# Access Compliance Report

## Public Rights-of-Way

### (Curb Ramps)

Intersection ID: 29979	Main Street: REIGATE_RD	Cross Street: ALBANS_LN	Location: SE
ADA ID: 435743515757	Ramp Type: PerpDiag	Initial Pass/Fail: Fail	Overall Compliance: No
Severity Score: 10			
Codes/Mitigation Info/Possible Solution		Field Measurements/Component Compliance

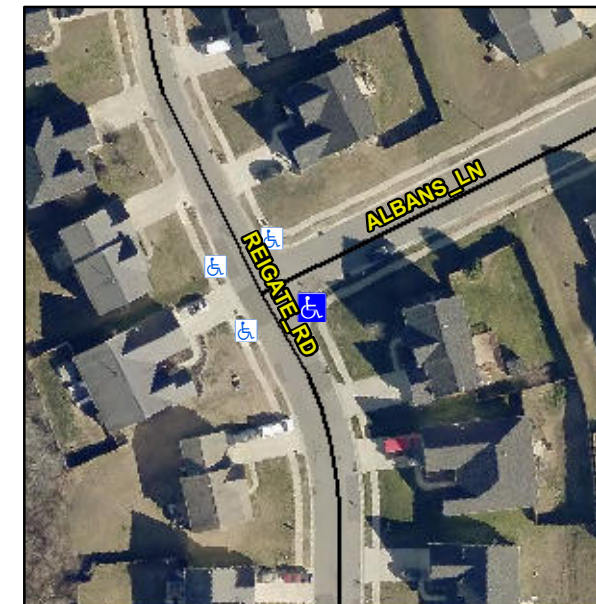
**R304.5.1, R304.5.3**

Compliance	Description	Data	Compliance	Description	Data
N/A	Ramp Length (in)	45.0	Yes	Ramp Slope (%)	7.8
No	Ramp Width (in)	36.0	No	Ramp XSlope (%)	3.3
N/A	Flare Type LT	N/A	N/A	Flare Type RT	N/A
N/A	Flare Slope LT (%)	N/A	N/A	Flare Slope RT (%)	N/A
N/A	Flare Traversable LT?	N/A	N/A	Flare Traversable RT?	N/A
N/A	Landing Length (in)	N/A	N/A	DWS Provided?	N/A
N/A	Landing Width (in)	N/A	N/A	DWS Contrast?	N/A
N/A	Landing Slope (%)	N/A	N/A	DWS Length (in)	N/A
N/A	Landing X Slope (%)	N/A	N/A	DWS Full Width?	N/A
N/A	Landing Curb? (Y/N)	N/A	N/A	DWS Offset (in)	N/A
N/A	Shared Landing?	N/A			
N/A	Gutter Ponding?	N/A	N/A	Gutter Slope (%)	N/A
N/A	Gutter Lip Ht (in)	N/A	N/A	Gutter X Slope (%)	N/A
N/A	Painted X Walk1?	No	N/A	Painted X Walk2?	No
	X Walk 1 Direction	To N		X Walk 2 Direction	To W
N/A	X Walk 1 Width (in)	N/A	N/A	X Walk 2 Width (in)	N/A
	X Walk 1 Slope (%)	1.4		X Walk 2 Slope (%)	2.0
	X Walk 1 X Slope (%)	0.5		X Walk 2 X Slope (%)	1.9

**Remove & Replace Curb Ramp With Two New Directional Ramps or Equivalent.**
